Re: Project Name: University of Nebraska- Lincoln NHLIA TI
DLR Group Project No.: 10-23123-00
City of Lincoln Record Number: B2302110

University of Nebraska
Nebraska Hospitality Leadership and Innovation Academy
Tenant Improvement
2101 Transformation Drive
Lincoln, NE. 68508

COMBINED CONTRACT
May 06, 2024

NOTICE TO BIDDERS:

FLOOR PLAN
GENERAL NOTES

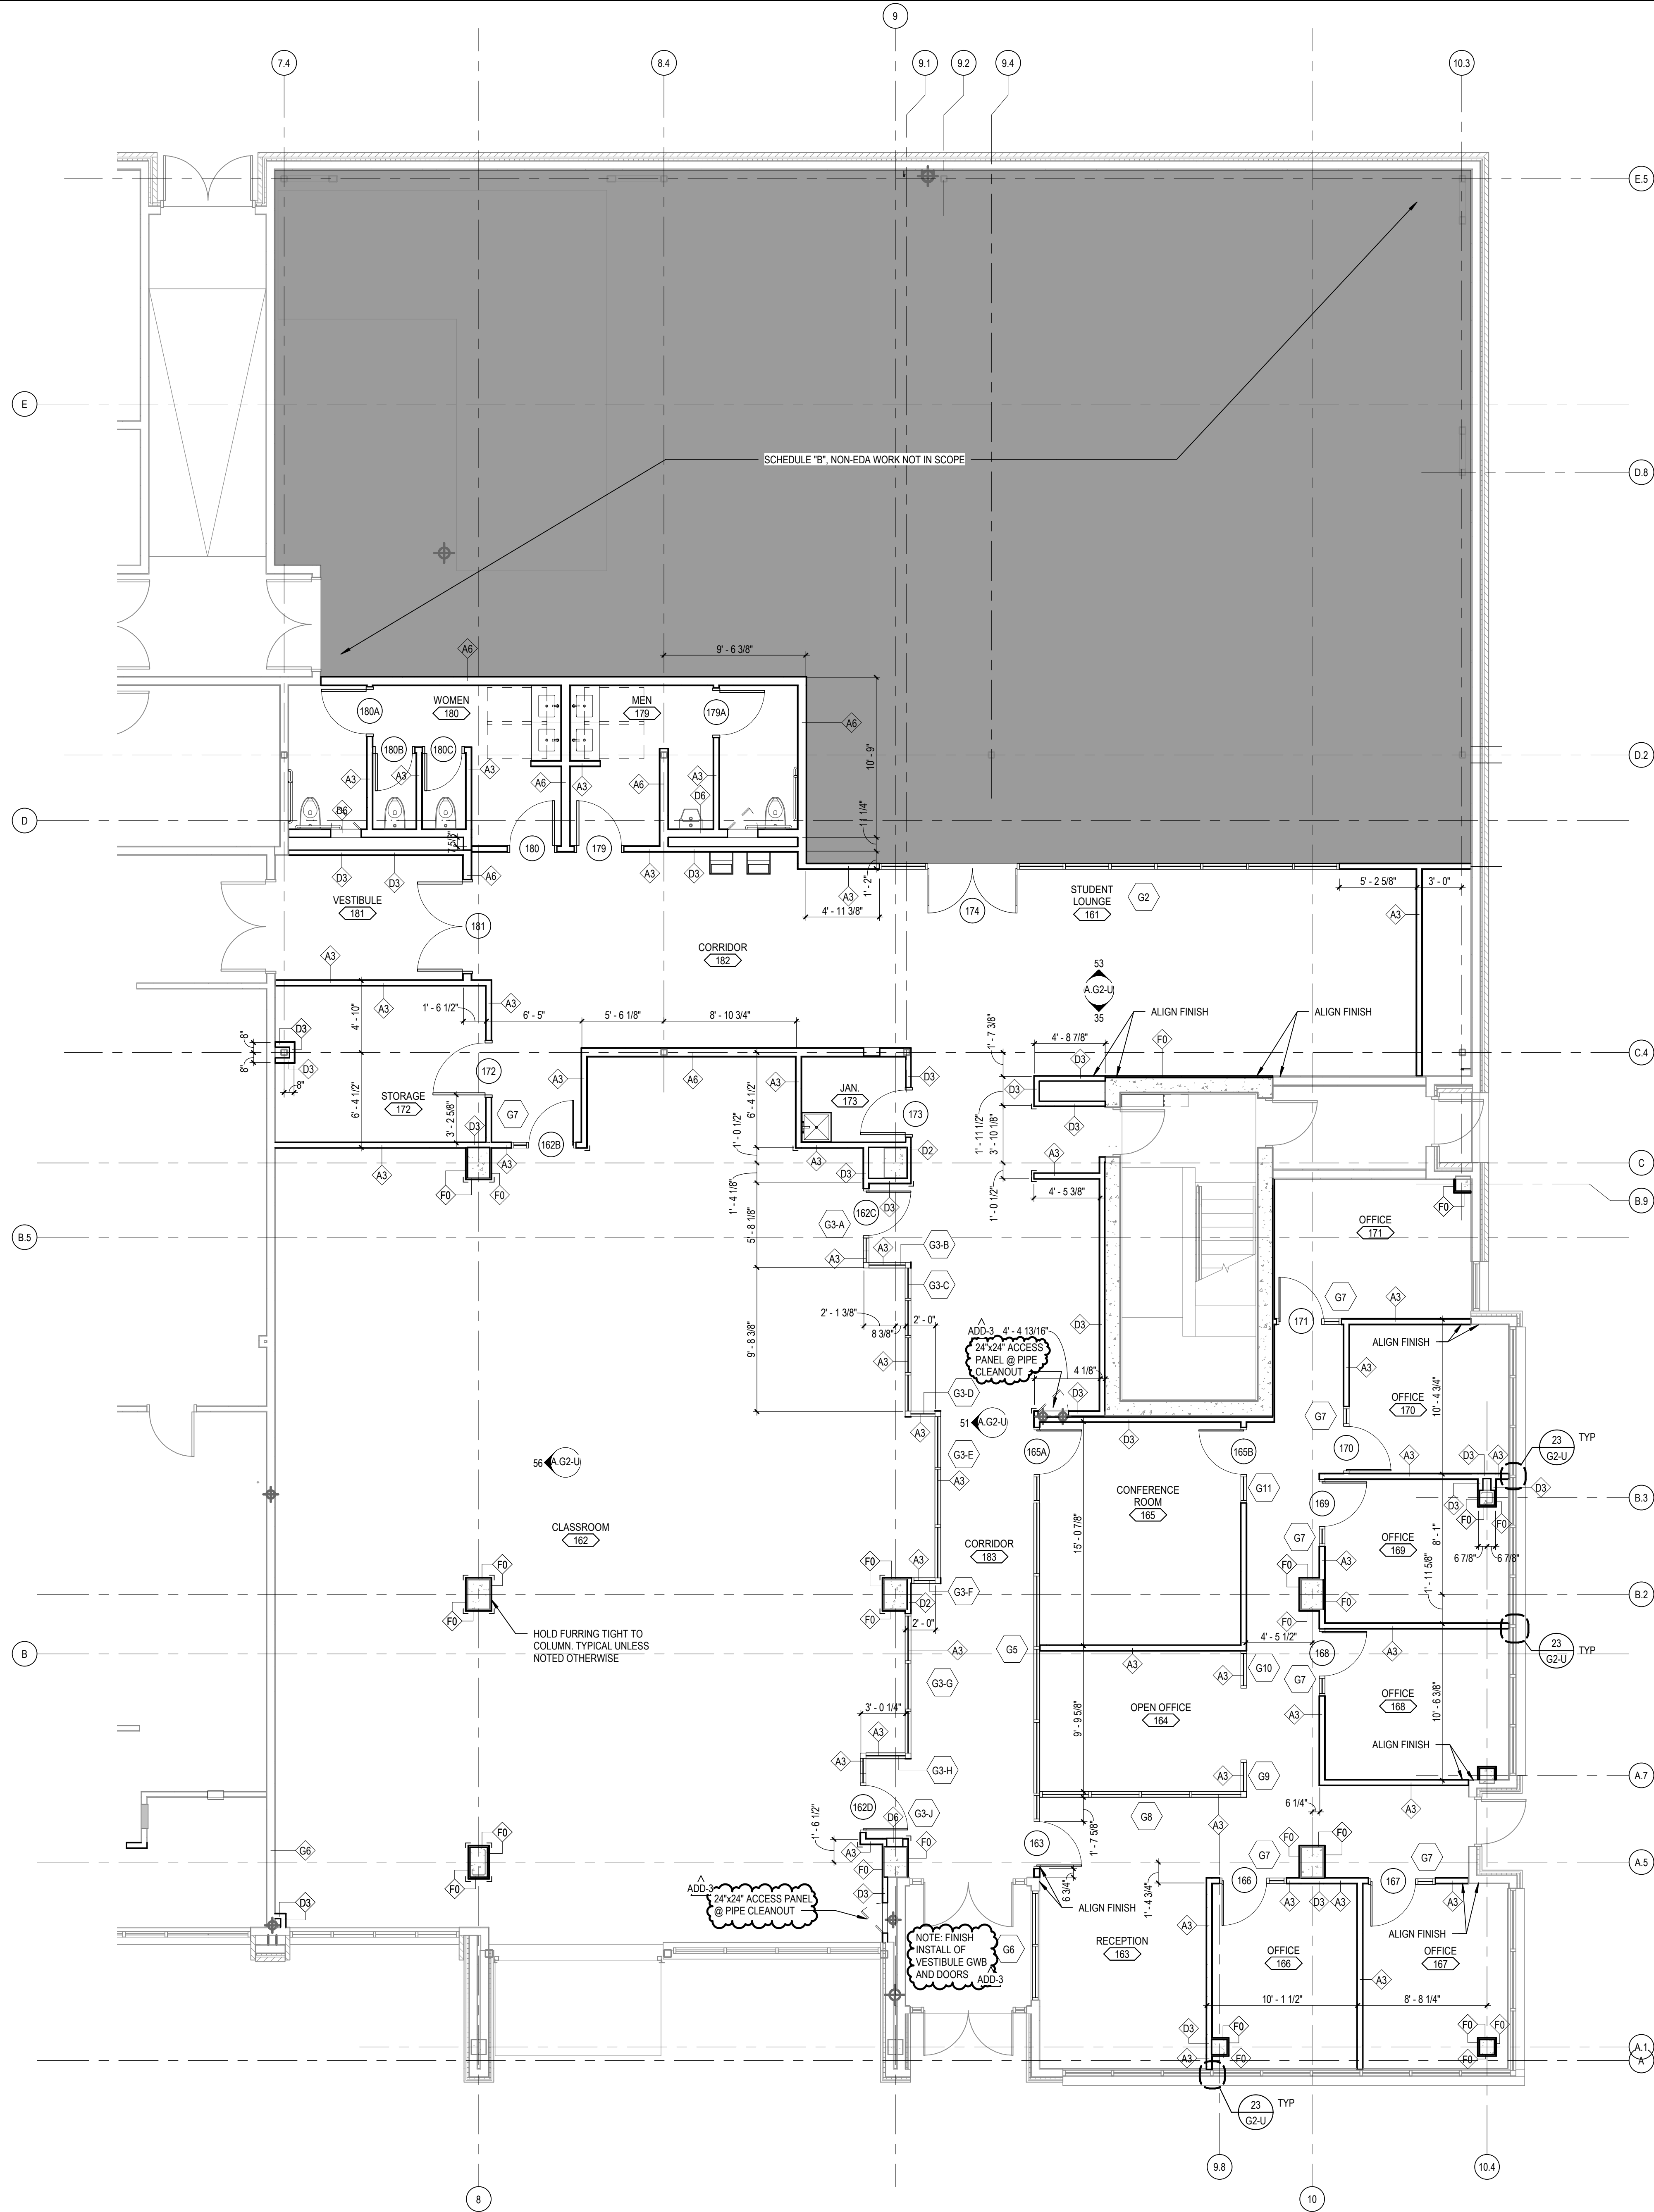
- A. Delete A.A1-U in its entirety and replace with attachment A.A1-U
 1. Notes added for access panel locations.
 2. Note added to finish vestibule work.
 3. General note added for contractor to install batt insulation in exterior wall stud cavities where missing.

14 TYPICAL HM HEAD JAMB DETAIL
A.A3.U SCALE: 1 1/2" = 1'-0"

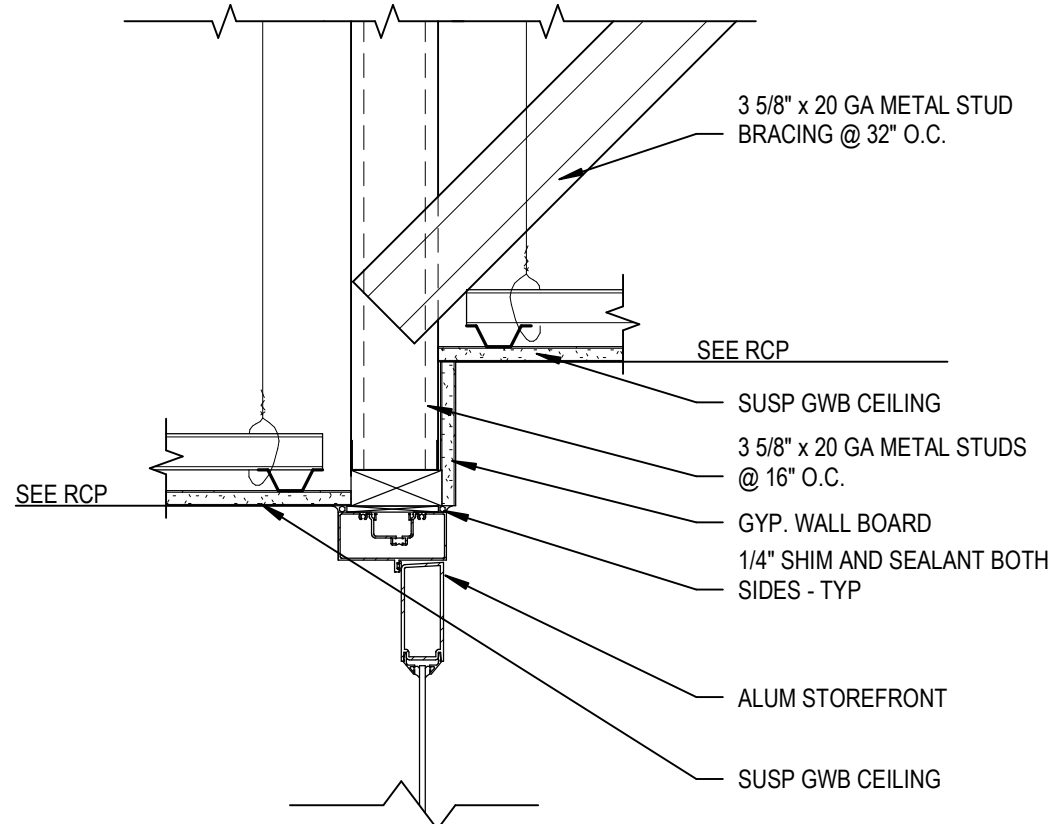
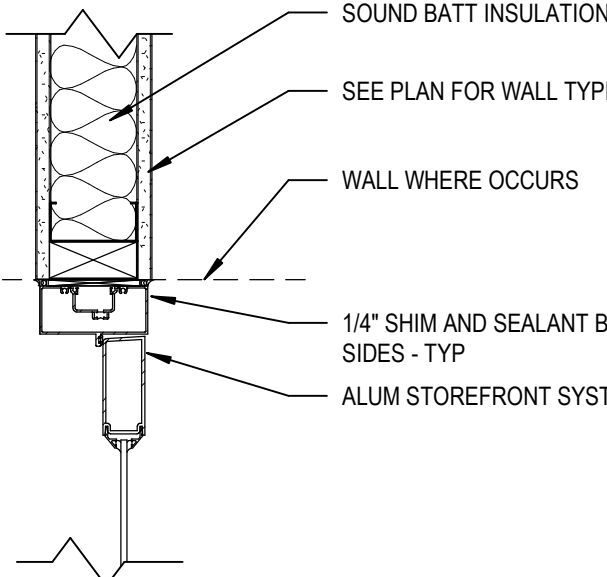
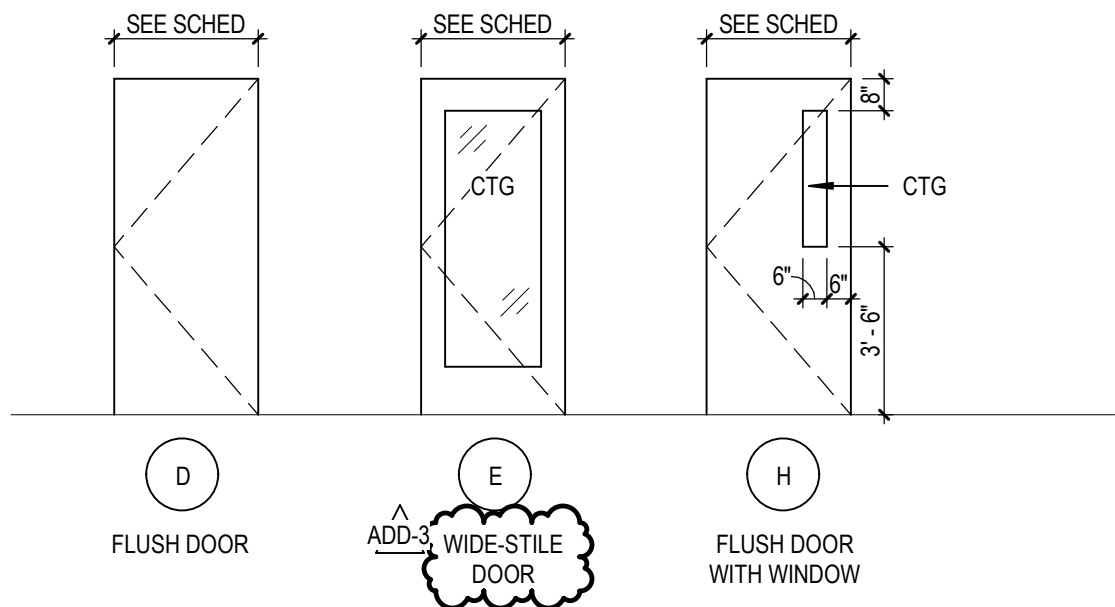
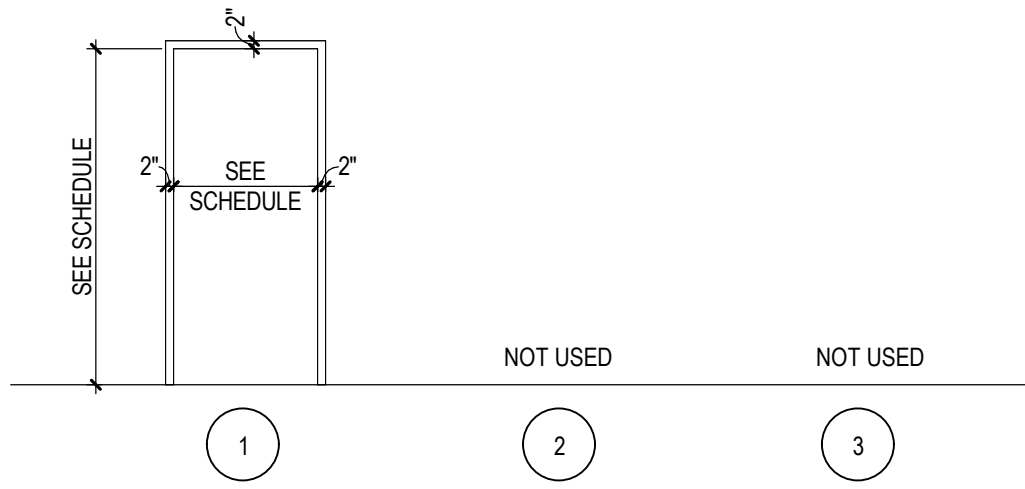
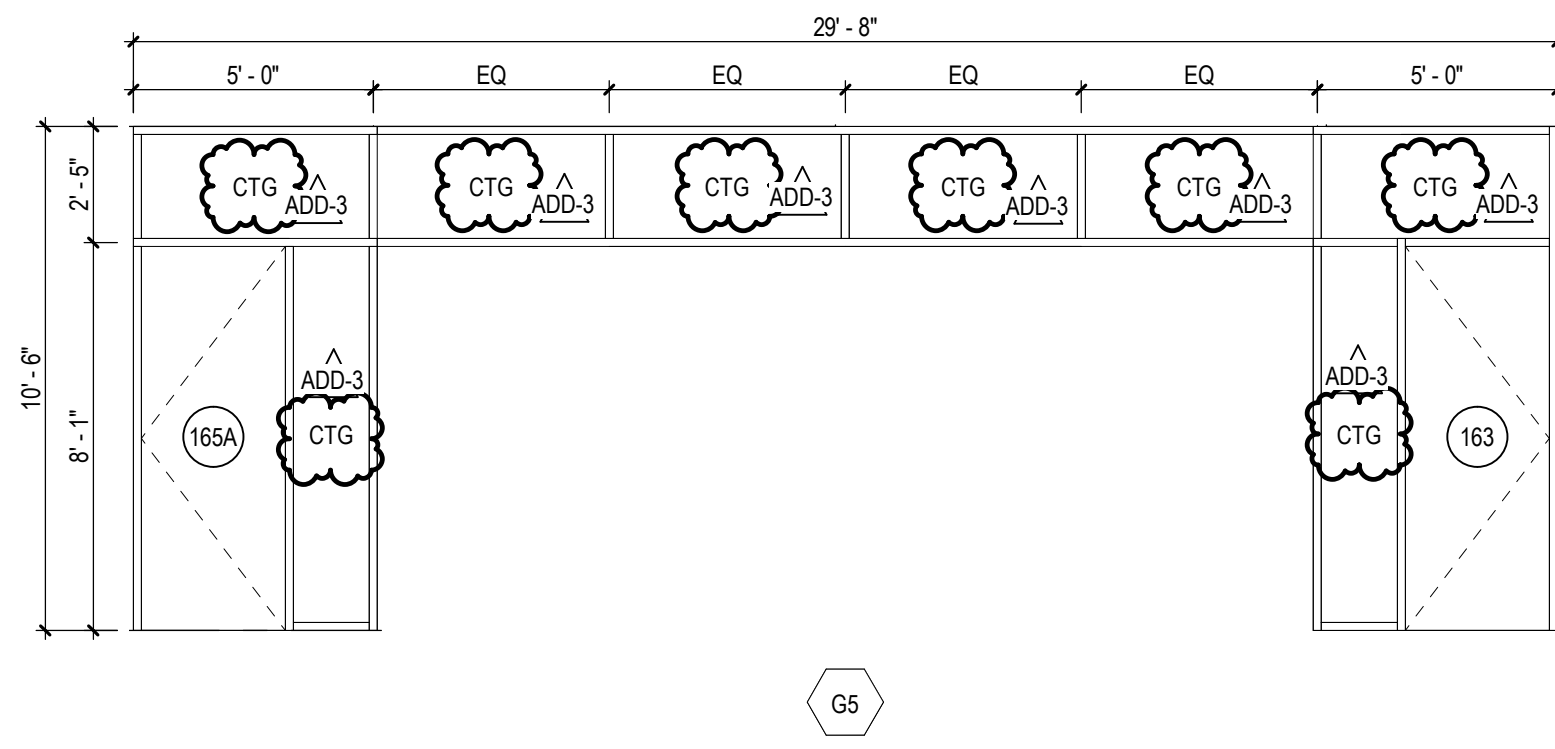
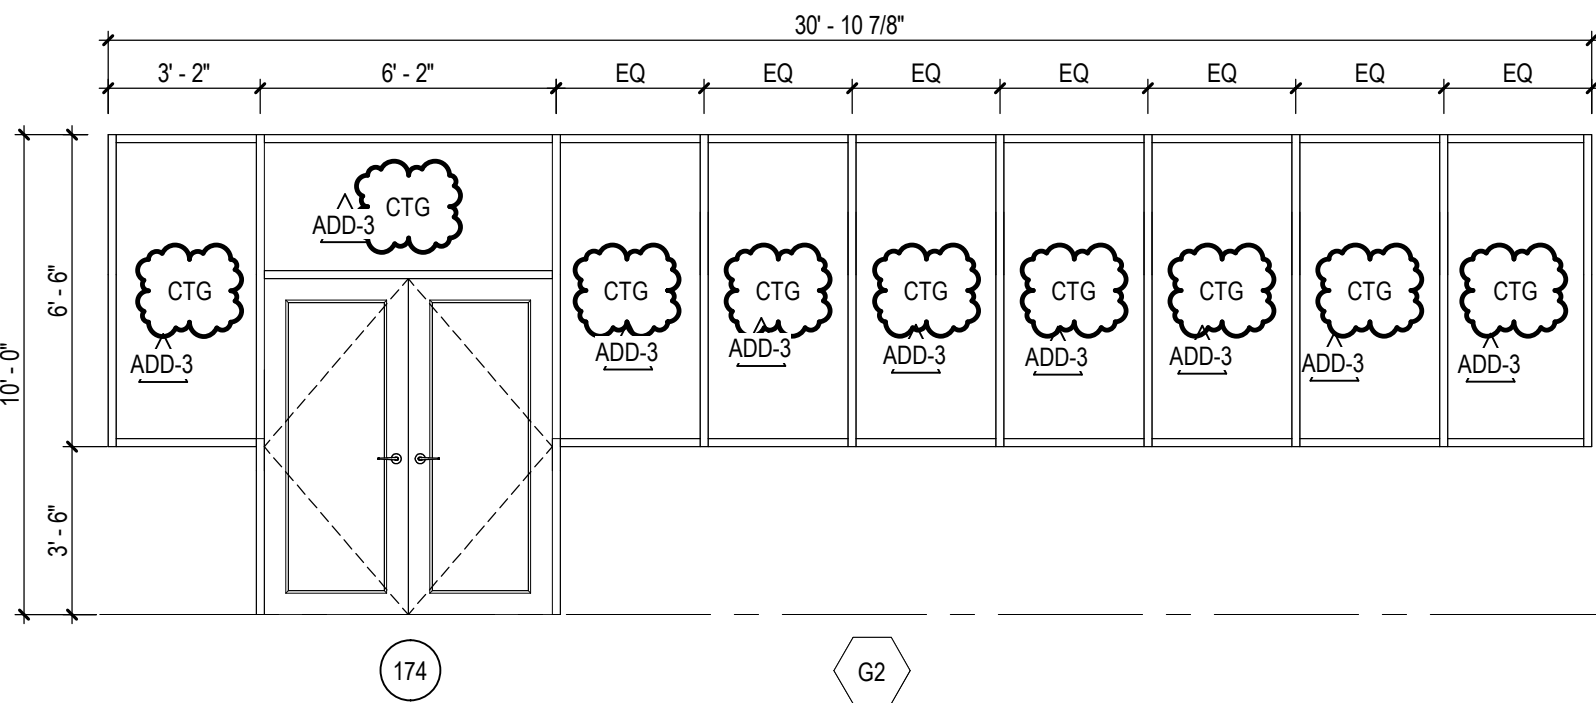
- A. Delete A.A3-U in its entirety and replace with attachment A.A3-U.
 1. Sidelight glazing type changed from CG to CTG.
 2. Door panel type “E” changed to Wide-Stile.
 3. DOOR AND FRAME SCHEDULE panel material types changed to ALUM.
